TOWNSHIP OF FRANKLIN
Planning Board
Agenda
Wednesday, June 3, 2026

AP REALTY GROUP, LLC / PLN-26-00006

Minor Subdivision w/C Variance in which the applicant seeks to subdivide the property into three lots at 426 Ralph Street, Somerset; Block 227 Lots 15-18 in zone R-7

Figure 3: Proposed Subdivision

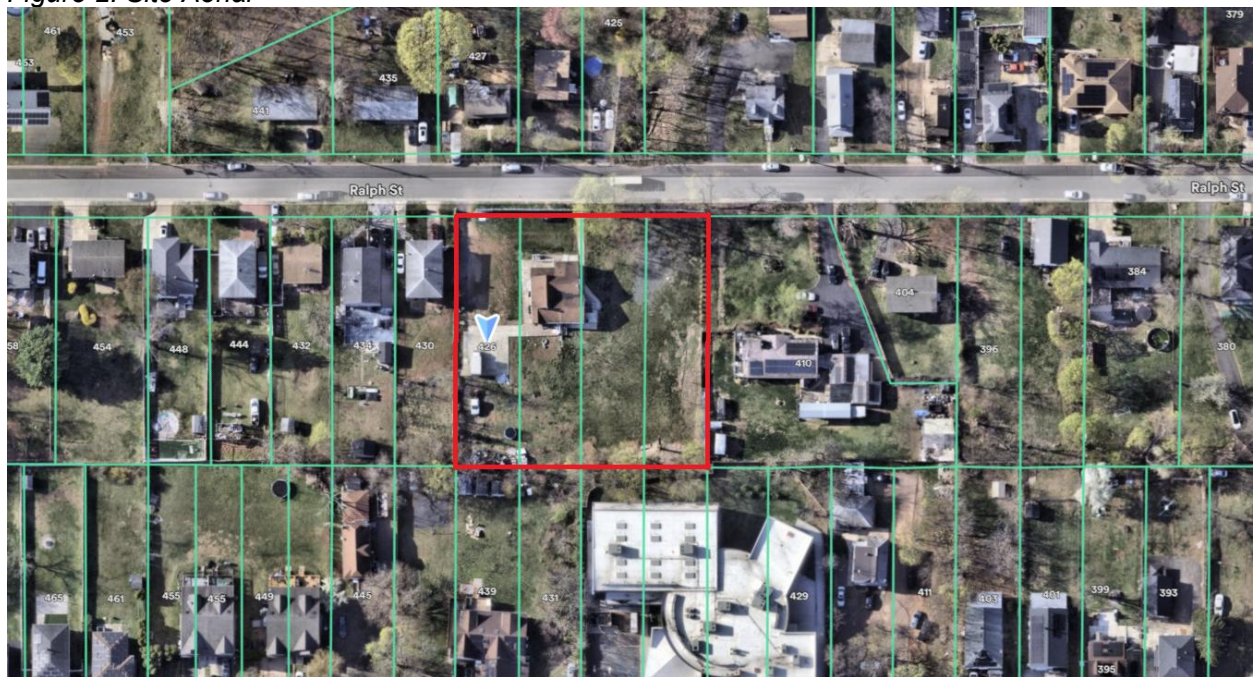
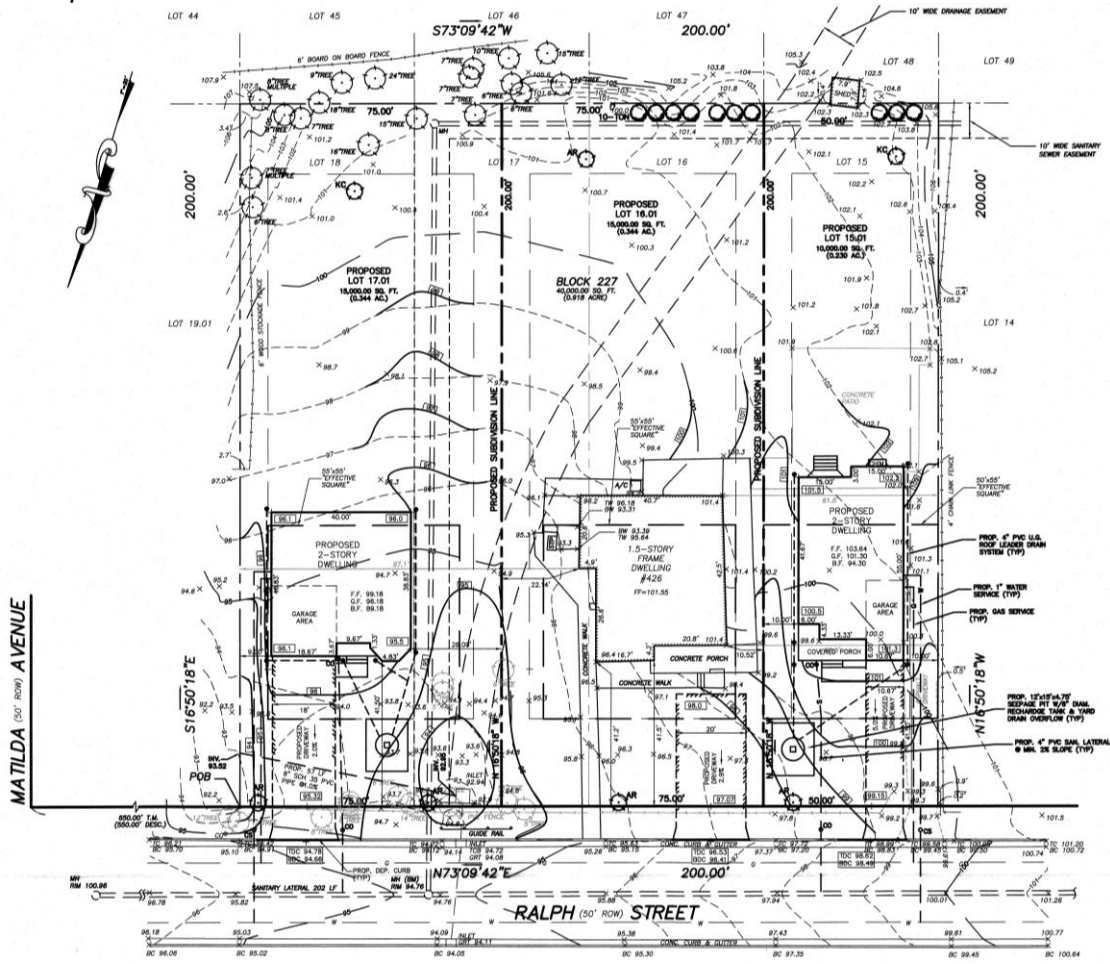
- On Sheet #1 on the set, "Water Demand" text is overwriting sewer demand text.
6. Soil Erosion and Sediment Control Plan:
 - Update the proposed lot numbering in accordance with Comment #1.
